**FEDERAL RECALL CAMPAIGN 07KW7  
2008 MODEL-YEAR T660 MODELS MANUFACTURED BETWEEN AUGUST 8, 2006 AND MARCH 9, 2007  
WITH CATERPILLAR C15 OR CUMMINS ISX ENGINES EQUIPPED WITH HORTON FAN BLADES**

**SITUATION**

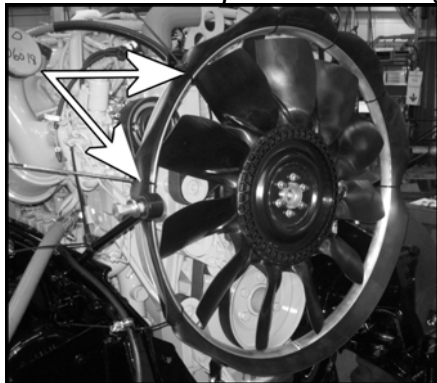
*Technician's Tip: Tie back ring shroud for easier radiator repositioning*

*Use tie straps to hold seal*

*Fold seal back to reinstall radiator*

- 9) Obtain replacement hub (see repair type **A**, or **B**) and reinstall. Align pulley, apply loctite to bolt threads and torque attaching bolts to 55-78 ft-lb.
- 10) Install replacement fan blade. Use loctite and torque nuts to 30-40 ft-lb.
- 11) Reposition cooling module and tighten lower radiator fasteners to 120-160 ft-lb.
- 12) Reinstall radiator tie rods. Torque to 120-160 ft-lb.
- 13) Reinstall radiator ring shroud ring. Apply medium loctite to bolt threads and torque to 16-22 ft-lb.
